The authors would like to express their gratitude to the Editor for handling the manuscript and to both of the Reviewers for their thoroughness and help in improving the quality of this manuscript with knowledgeable and constructive comments. We also thank the reviewers for underlining the need for metrology and in-situ sampling of monoterpenes by supporting this manuscript. We appreciate their time and effort in contributing. We hereafter provide a point by point response to their comments.

Reviewer 1 Comments

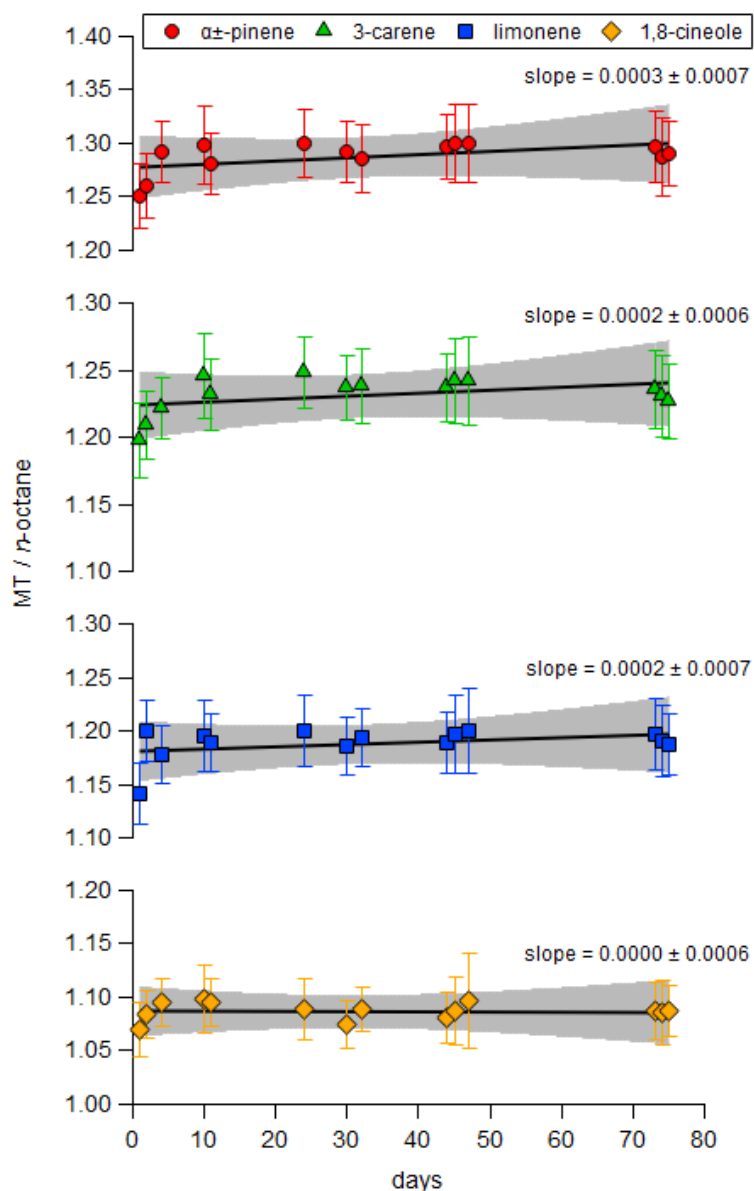
Line 382 and Figure 5: One of the major outcomes of this study is the stability of the monoterpenes studied in one type of cylinder. This is shown in Figure 5 but this finding is backed up by surprisingly little statistical analysis. “appears [...] fairly constant” is the only description accompanying the plots in Figure 5. I feel that the conclusions of this study would be stronger if backed up by a more solid analysis. I would like the authors to add a weighted least-squares fit to the plots in Figure 5 and comment on the magnitude of the gradients in the light of its associated uncertainties from the fit. I would be surprised if this analysis did not support the authors’ conclusions, but it needs to be shown. Also crop the x-axis at 80 days.

The authors agree with the Reviewer’s comments and have done a weighted least fit squares regression analysis. Figure 5 has been modified to include this fitting and confidence intervals have been added. The x-axis has also been cropped, as shown below:

The following sentence has been added: "Regression analysis using a least squares fit shows that the gradients for all four monoterpenes are within the measurement uncertainty of zero showing no statistically significant change in amount fraction over the 75 day timeframe."

Figure 5 caption now reads: "The short-term stability of reference PRM (mixture BB) at nominally 2 nmol mol⁻¹ compared as a ratio of the area of each monoterpene normalised relative to the n-octane internal standard. Error bars are included to account for the relative standard deviation of the mean ($k = 2$). The solid lines show the results of a linear least squares fitting routine with the shaded area showing the confidence interval (95 %) of the fit."
